Title of Change:	Change TO247 mold downset A1 remark position from lead tip to lead root.
Effective date:	06 Jan 2020
Contact information:	Contact your local ON Semiconductor Sales Office or Daisy.Zhi@onsemi.com
Type of notification:	This Product Bulletin is for notification purposes only. ON Semiconductor will proceed with implementation of this change upon publication of this Product Bulletin.
Change Category:	Assembly Change
Change Sub-Category(s):	Datasheet/Product Doc change

Description and Purpose:

Example:

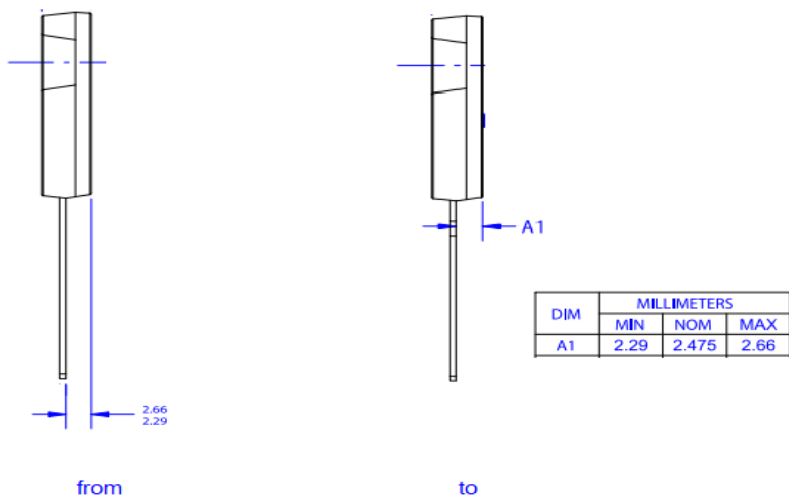
Change A1 remark position from lead tip to lead root, value no change.

Impact MOD are: 340CD, 340CF, 340CH, 340CJ, 340CK, 340CL, 340CU, 340CW, 340CX. This to follow ON standard drawing style and eliminate the confusion from internal and external.
